ALLAMAKEE CSD MIDDLE SCHOOL HVAC UPGRADE
WAUKON, IOWA

ADDENDUM 01
March 2, 2026

M-101B

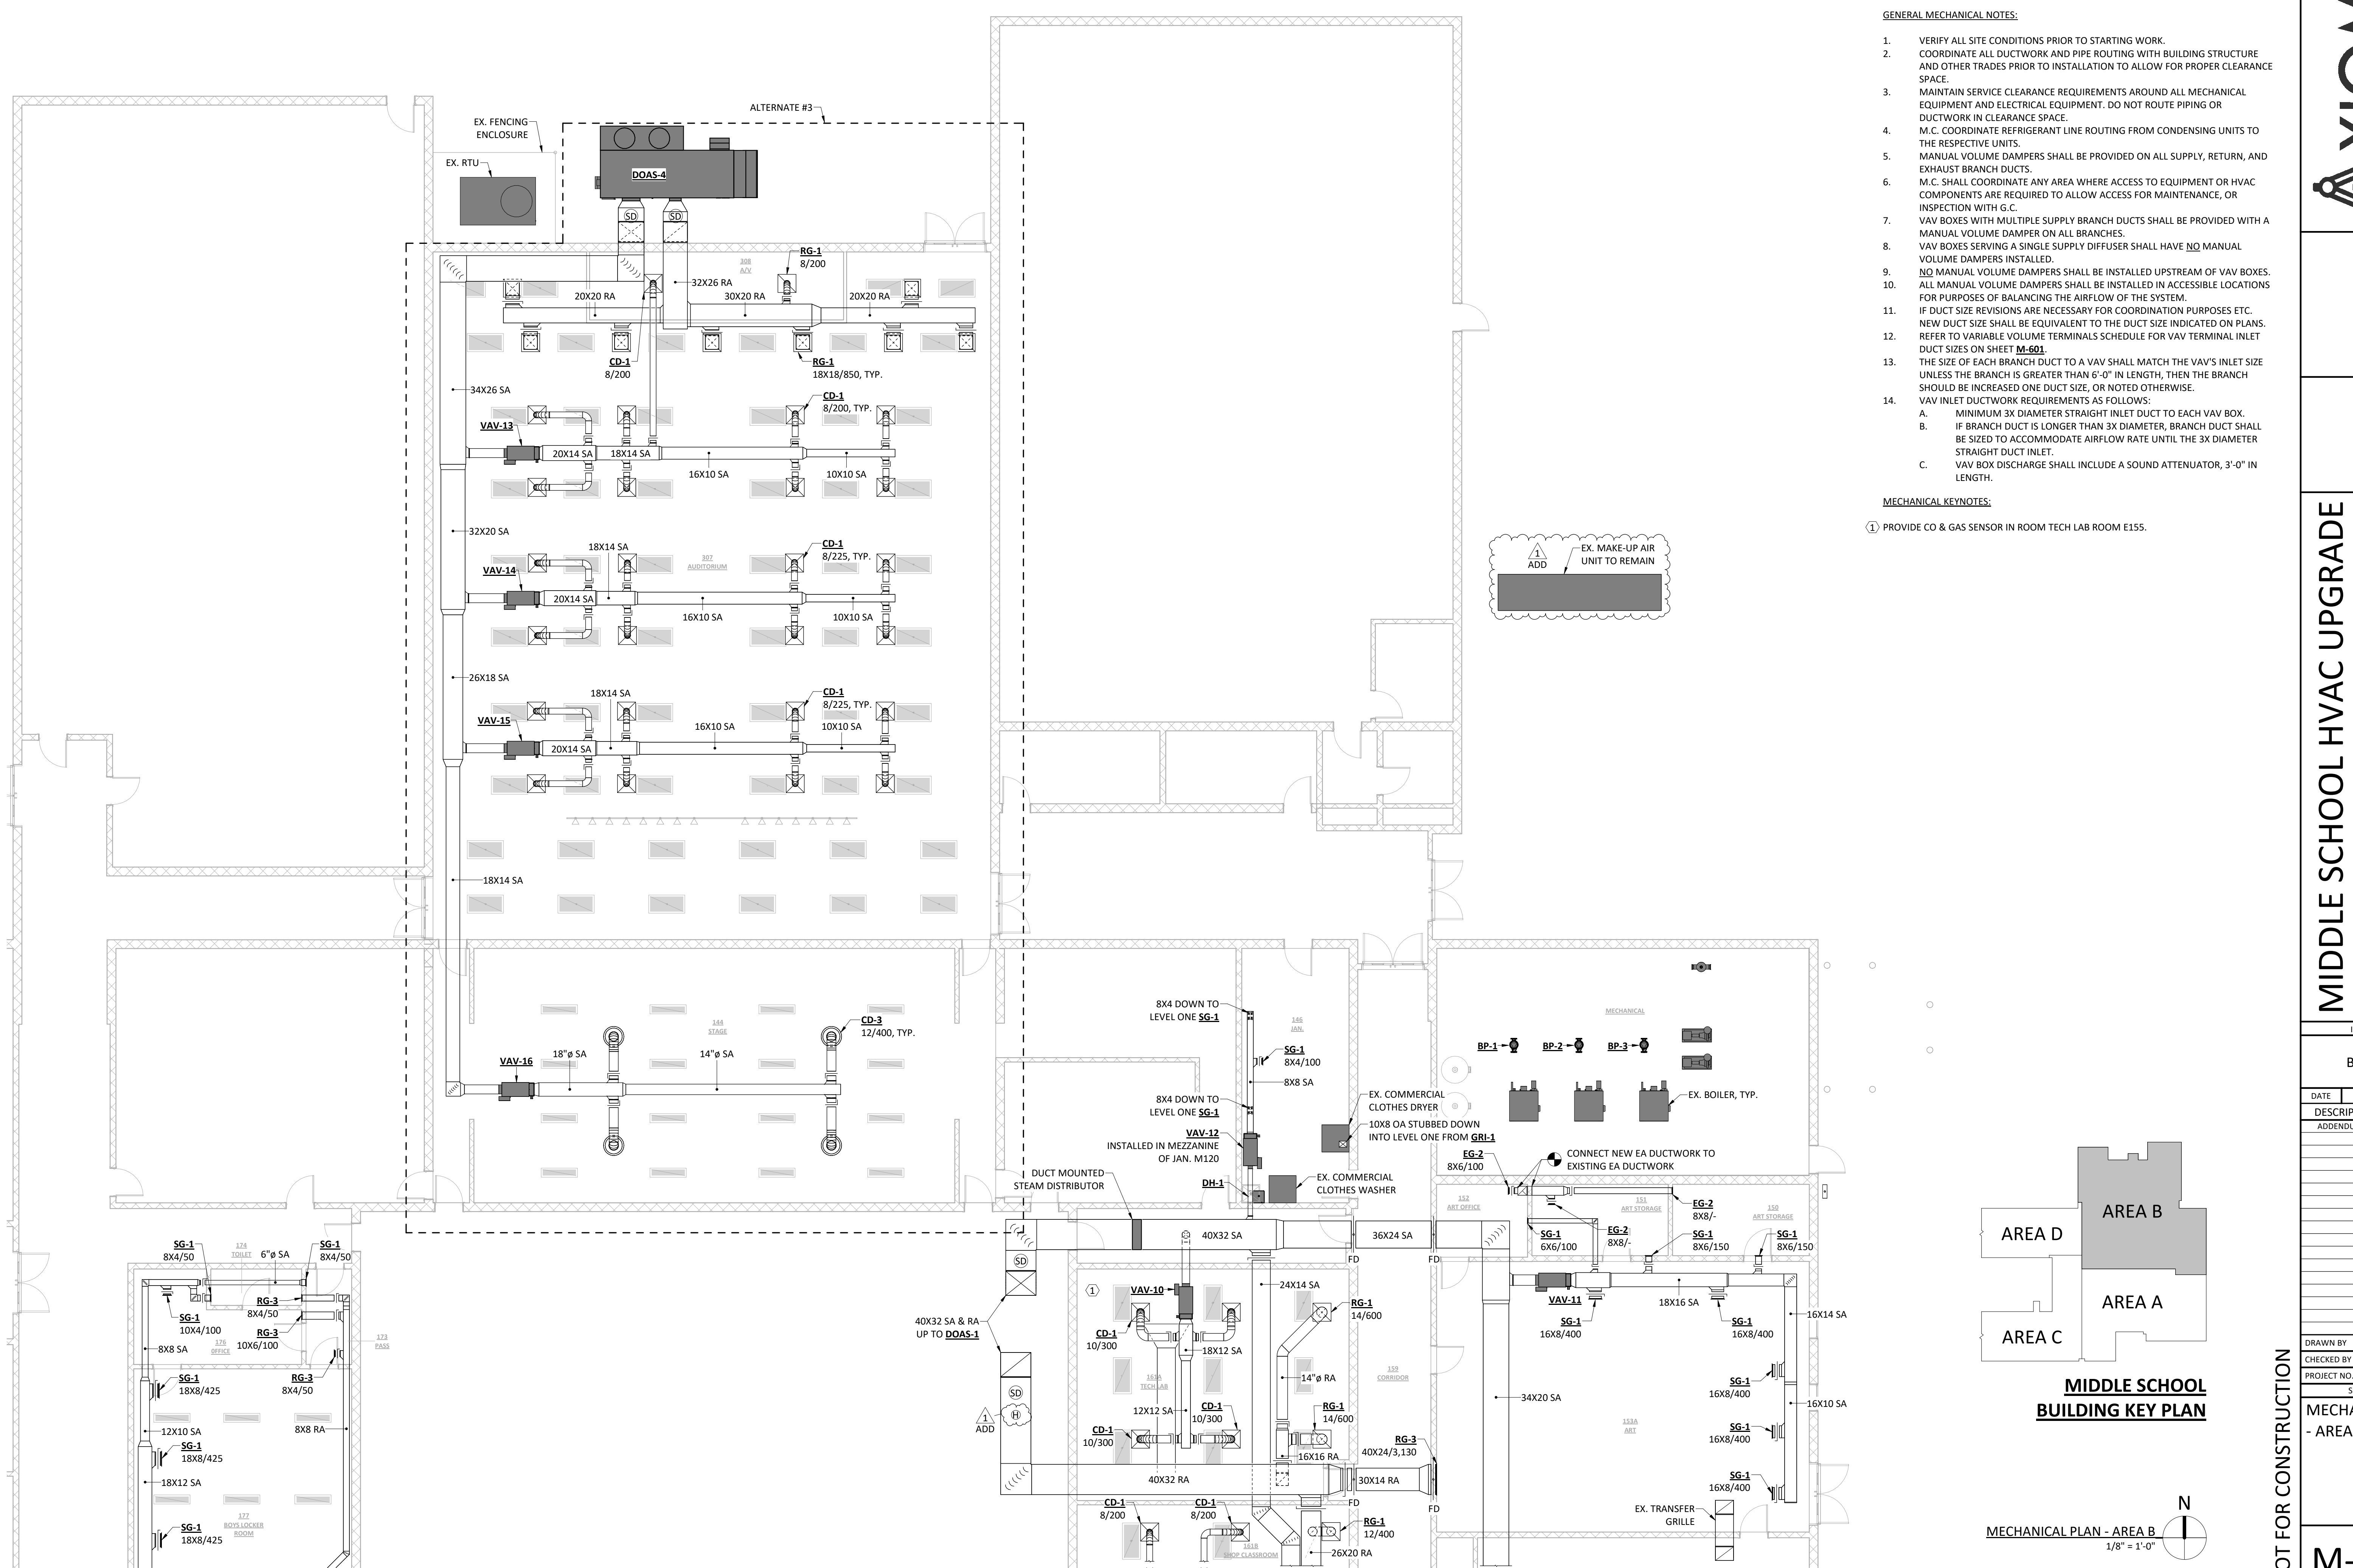
4. Revised UV-9 to be ceiling cassette style unit ventilator.
- M1-2 Drawing **M-101B – MECHANICAL PLAN – AREA B**
1. Relocated humidistat for DH-1 to DOAS-1 return ductwork.

2. Show existing make-up air unit to remain.
- M1-3 Drawing **M-101C – MECHANICAL PLAN – AREA C**
1. Relocated humidistat for DH-3 to existing DOAS S return ductwork.

MIDDLE SCHOOL BUILDING KEY PLAN
MECHANICAL PIPING & CONTROLS PLAN - AREA B
1/8" = 1'-0"

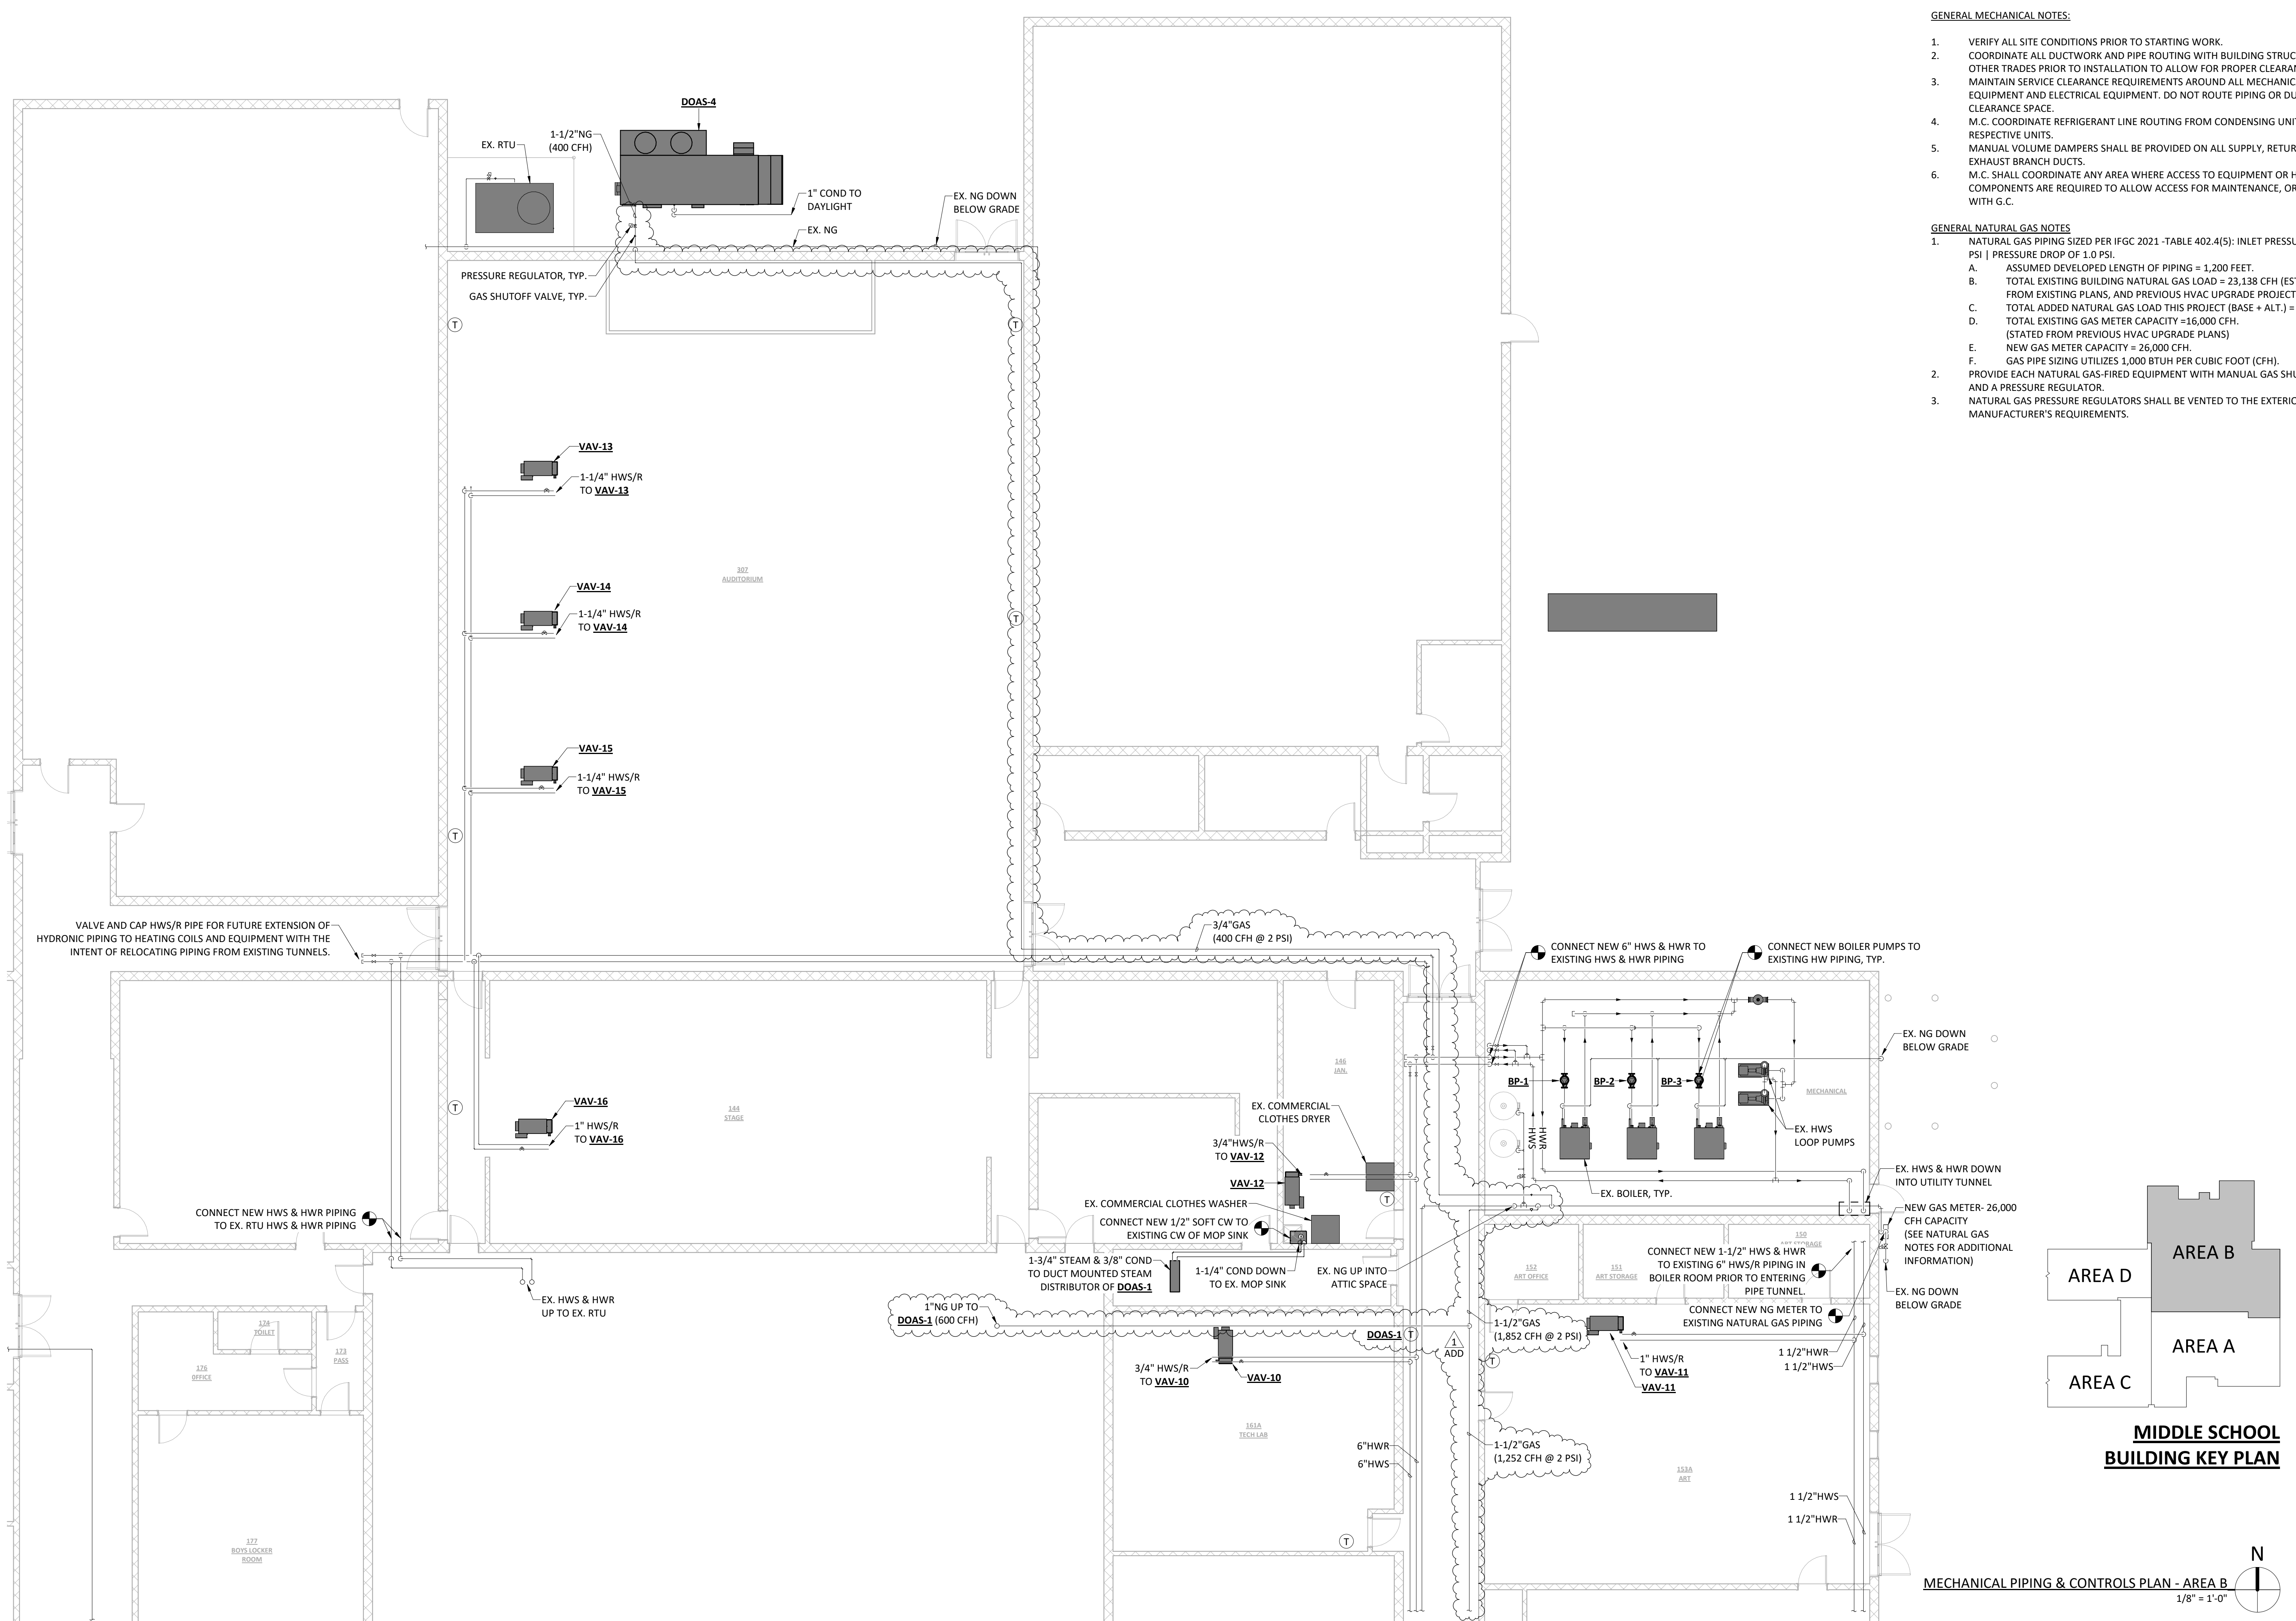
- M1-6 Drawing **M-111B – MECHANICAL PIPING & CONTROLS PLAN – AREA B**
1. Revised gas piping to new HVAC equipment to be standalone branch ran from mechanical room.

M-111D

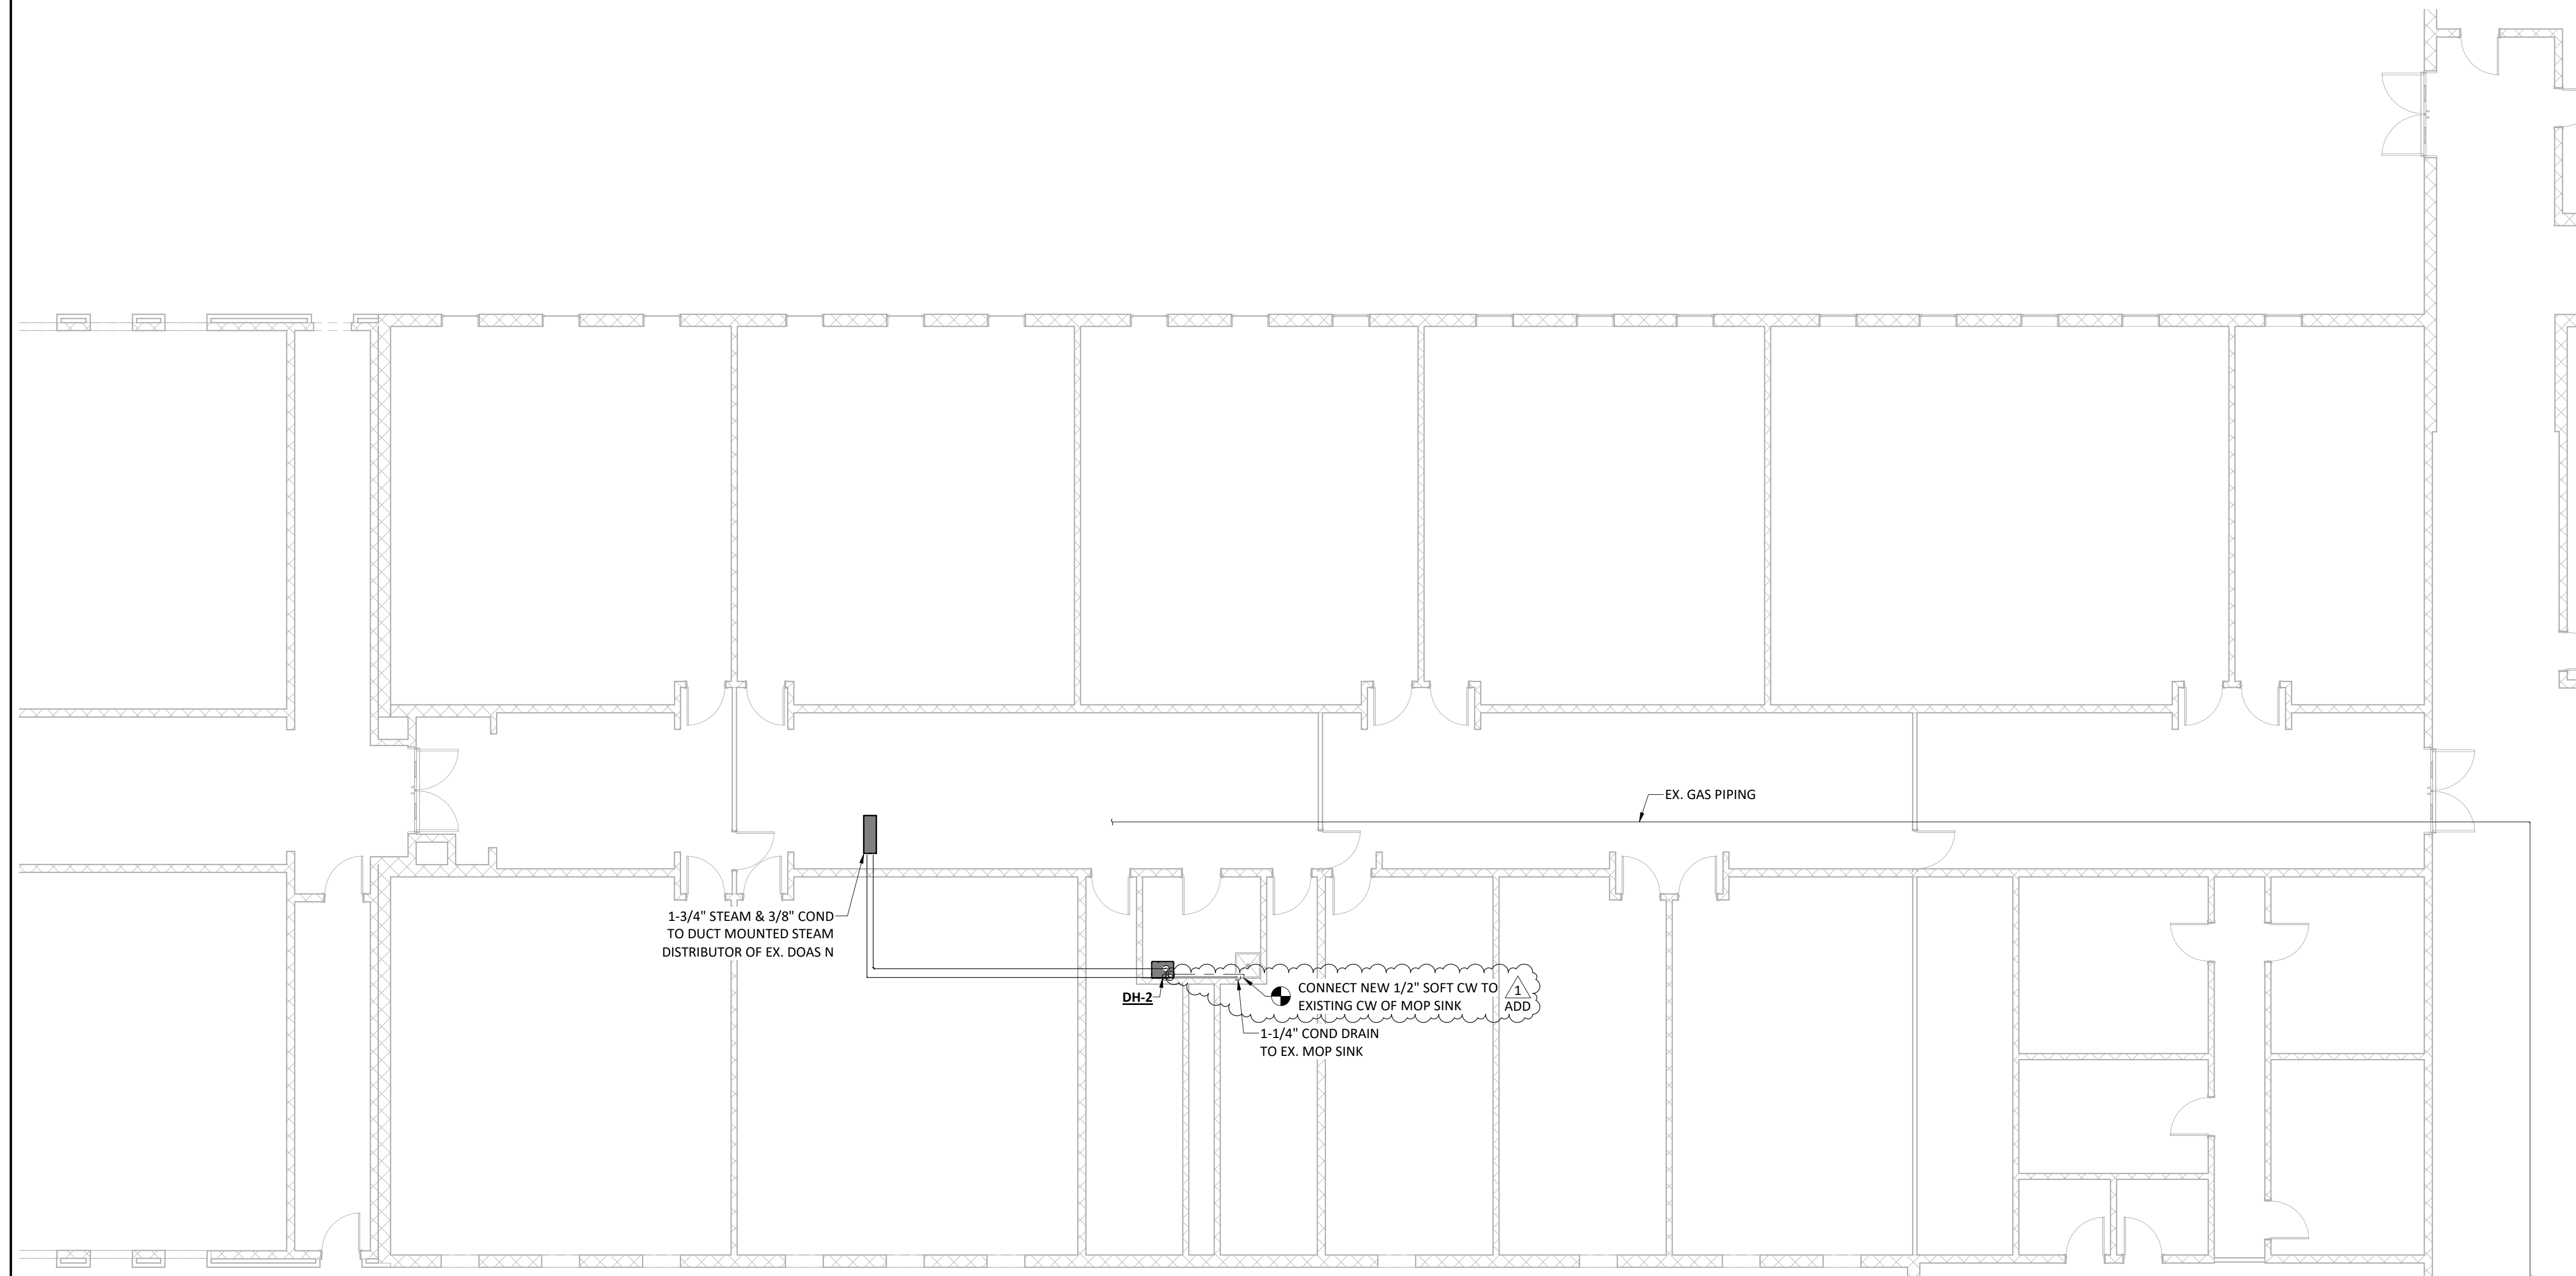
1. Show soft water piping connection to DH-2.
- M1-9 Drawing **M-201 – MECHANICAL ROOF PLAN**
1. Revised kitchen hood makeup to be provided by individual makeup air units MAU-1, MAU-2, and MAU-3 (one per cooking exhaust hood).
